Access Compliance Report

Public Rights-of-Way

| Intersection ID: 46736 | Main Street: ROBINSON_MEADOW_CT | Cross Street: BEAVER_BROOK_WY | Location: E |
| ADA ID: BECF9DD86E01 | Ramp Type: BlendTrans1 | Initial Pass/Fail: Fail | Overall Compliance: No |

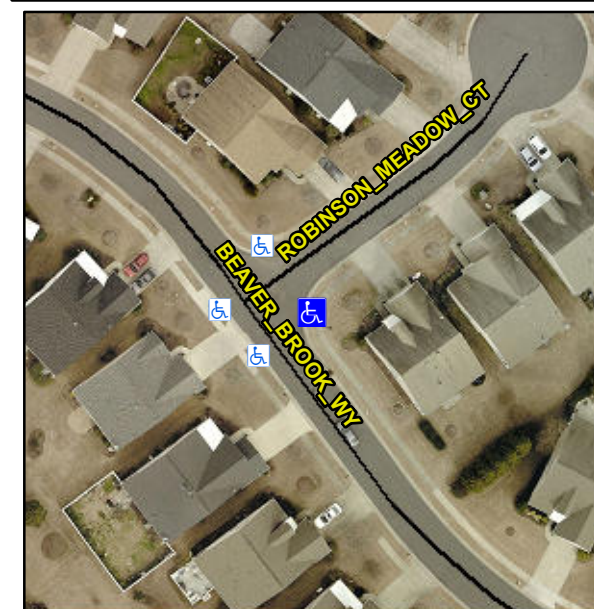
Not Found, R304.5.1, R304.5.3

| Compliance | Description | Data | Compliance | Description | Data |
|------------|-----------------------|-------|------------|-----------------------------|-------|
| No | Ramp Width (in) | 39.0 | No | BlendTrans XSlope (%) | 3.0 |

Remove & Replace Curb Ramp With Two New Directional Ramps or Equivalent.
